Appl. № 10/708,191
Amdt. dated 6 April 2006
Reply to Office Action of 28 December 2005

Amendments to the Drawings:

REMARKS/ARGUMENTS

Appl. No. 10/708, 191
Amdt. Dated 06 April 2006
Reply to Office Action of 28 December 2005
Annotated Sheet Showing Changes

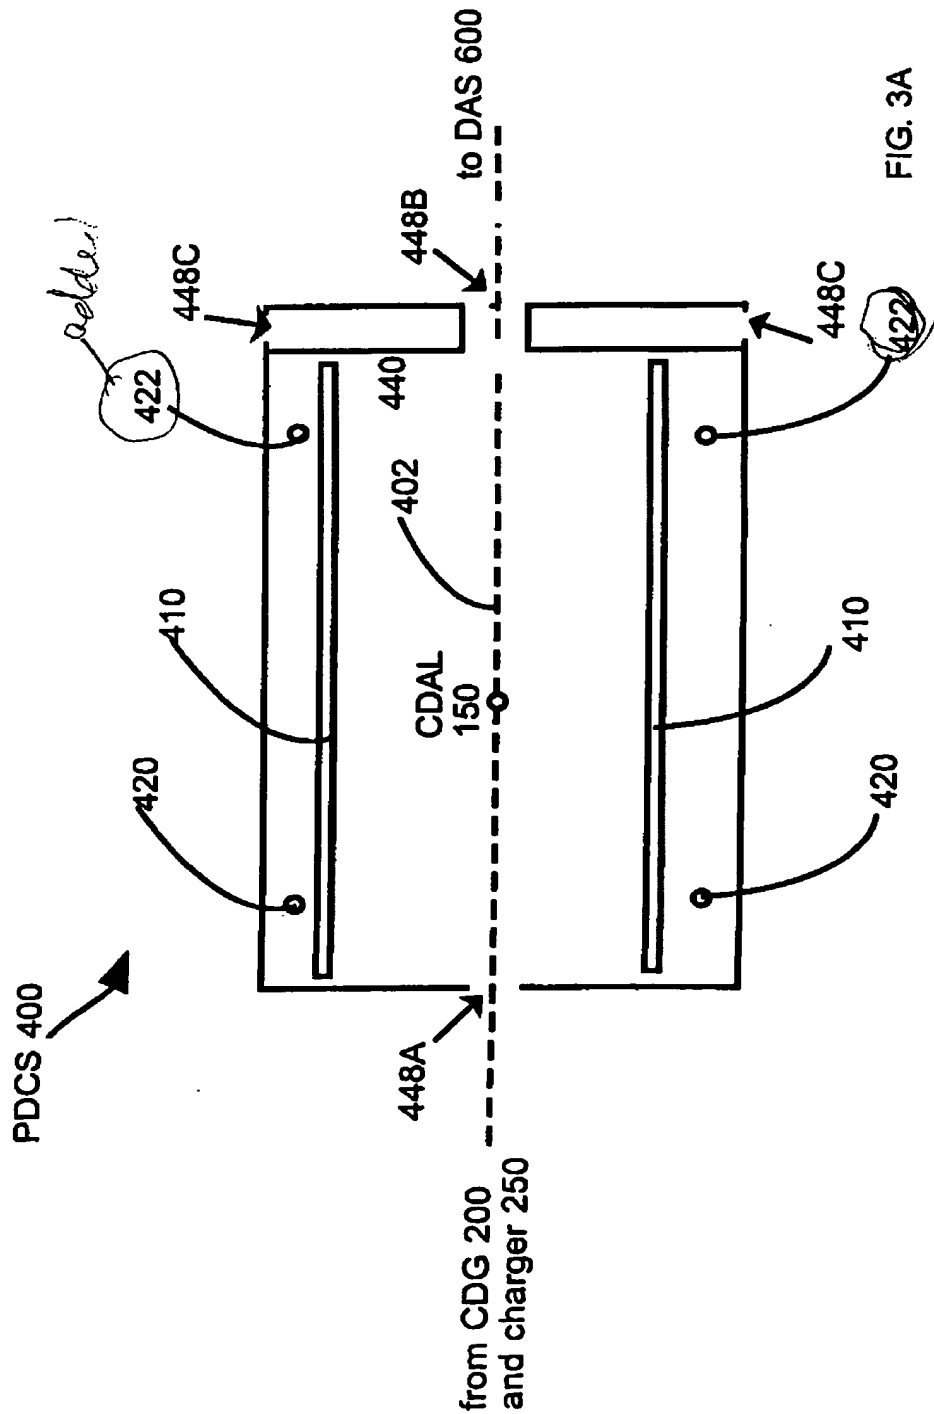
The attached sheet of drawings includes changes to Fig. 2. This sheet replaces the original sheet. In Figure 2, previously omitted reference number 820 has been added.

In paragraph [0054] there is reference to "structure-switching signaling aptamer 820" but it is not shown in the referenced Figure 2. Figure 2 has been corrected.

FIG. 3E

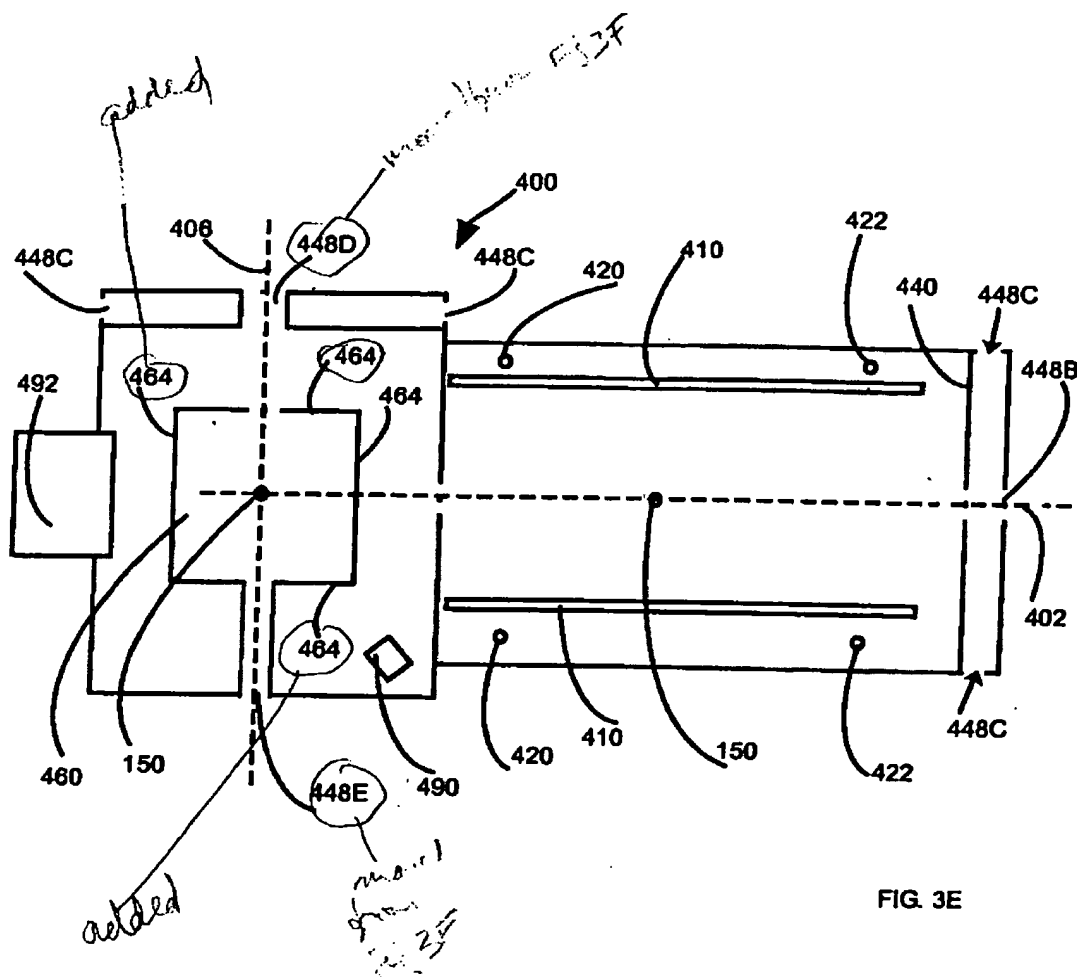
The attached Replacement Sheet showing FIG. 3E adds several reference numerals referred to in the specification and not previously listed and moves several reference numerals from redundant FIG. 3F. Specifically Reference numeral 464 is added in several locations and Reference numerals 448D & E are moved from deleted FIG. 3F.

Paragraph [0058] references "CEDB electrodes 464" as disclosed in Figure 3E but it is not found in Figure 3E. The label has been added to the figure and the text has been modified to more clearly state the invention.

Reference numbers 448D & 448E are displayed in Figures 3E & 3F but not described in the specification. Figure 3F is deleted along with mention of figure 3F in the specification. Figure 3E is corrected to cover the removal of an now unnecessary figure.

FIG. 4A

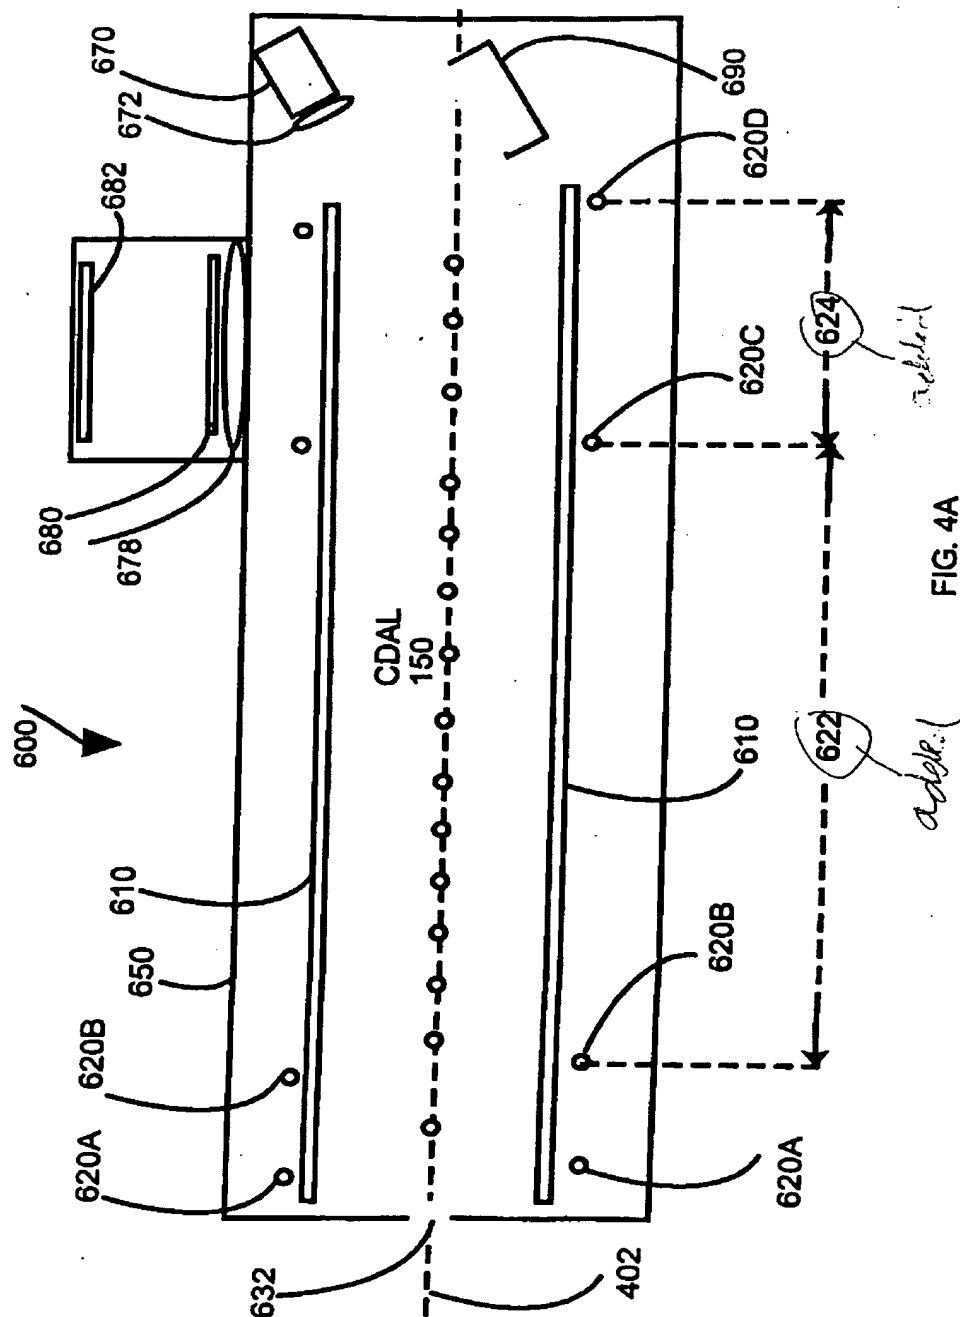
The attached Replacement Sheet showing FIG 4A is amended to illustrate the elements referred to in the specification as "holding region 622" and "measurement region 624" respectively.

Paragraphs [0060] and [0061] reference "holding region 622" and "measurement region 624" in Figure 4A but these regions are not found in the referenced drawing. Figure 4A has been amended to show the two regions referred to in the specification.

FIG. 4B

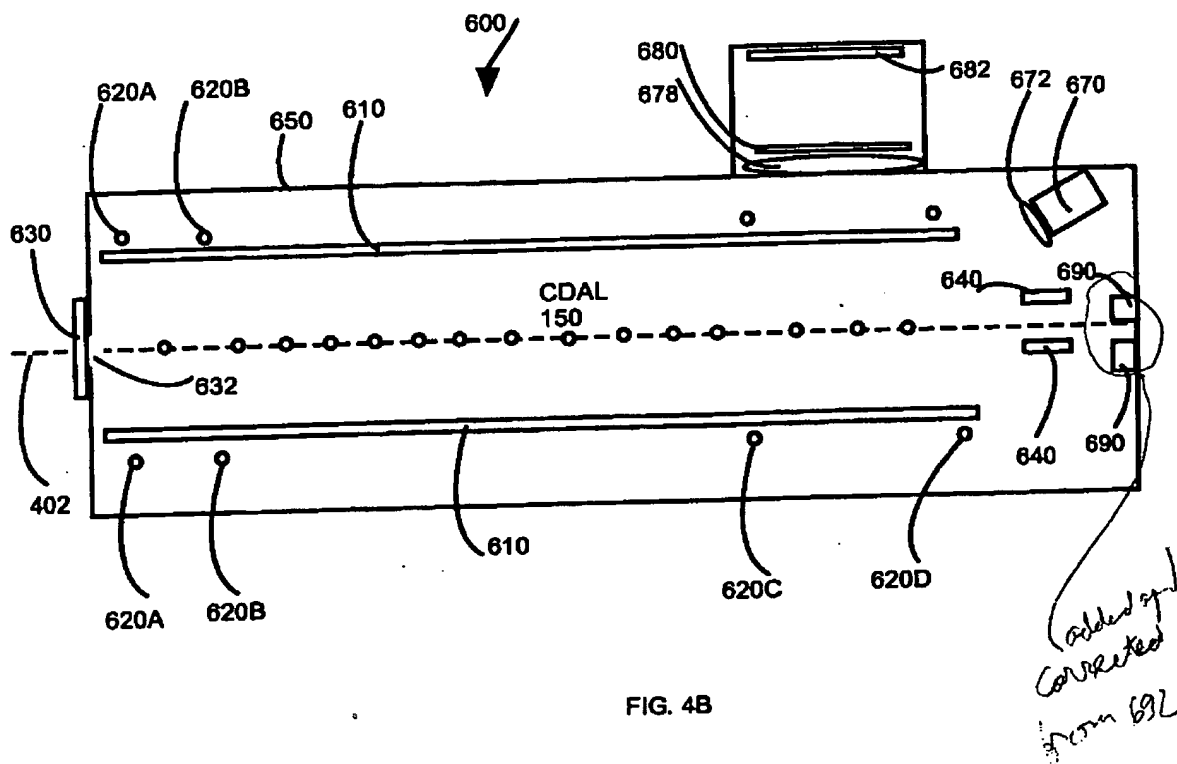
The attached Replacement Sheet showing FIG 4B is amended to designate the elements referred to in the specification as "two receptacles 690" from the incorrect "692".

Paragraph [0063] references "two receptacles 690" in figure 4B but these receptacles are not illustrated in figure 4B. Figure 4B has been modified to show the two receptacles. They were in correctly referenced as "692".

Figure 4B displays reference number 692 but this number is not described in the specification. The figure is amended to correct “692” to “690” which is discussed in the specification.
